# Product Change Notification

## 113331 - 00

**Change Notification #:** 113331 - 00  
**Change Title:** Intel® Server System R2308GL4GS  
PCN 113331-00, Product Design  
Update the System Rear Panel  
**Date of Publication:** October 22, 2014

Figure One

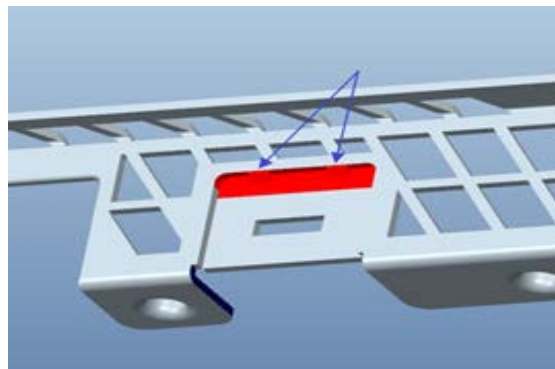
1. Update the one big center joint to two smaller joints so that the joints will not conflict with the LAN cable connector latch. See Figure One.

Figure Two

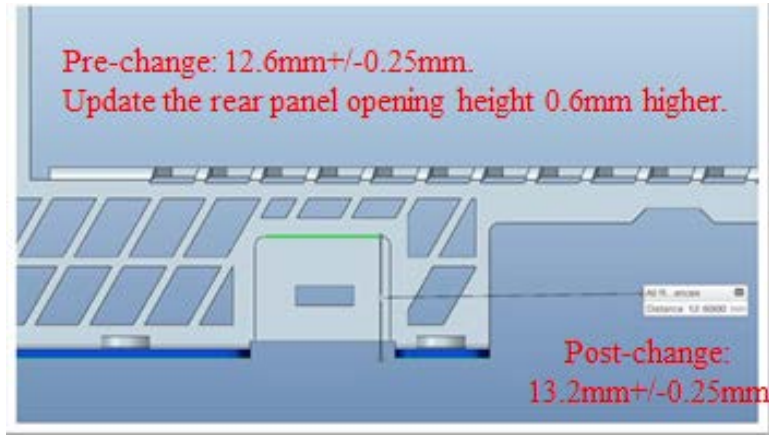
2. Update the rear panel opening height 0.6mm higher to improve the flexibility for the cable latch. The previous height was 12.6mm+/-0.25mm. The updated height is 13.2mm+/-0.25mm. See Figure Two.

Figure Three

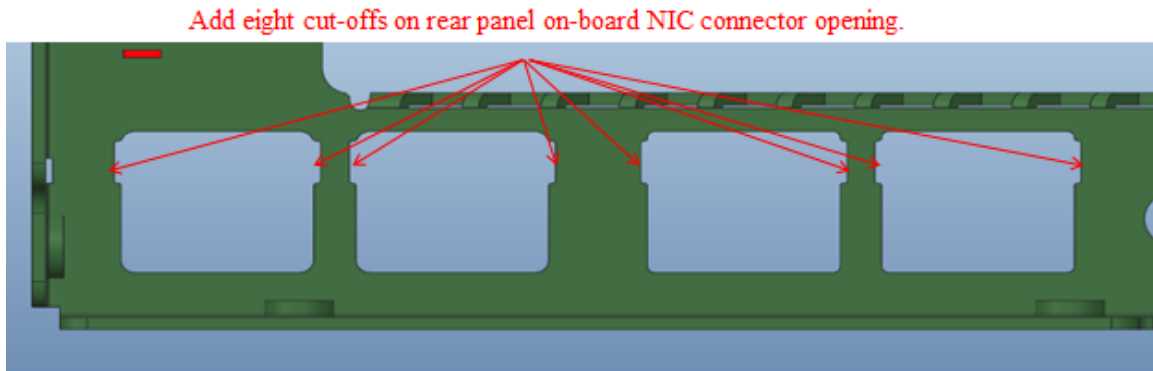
3. Add eight cut-offs around the on-board NIC (Network Interface Controller) openings to improve the LED visibility. See Figure Three.
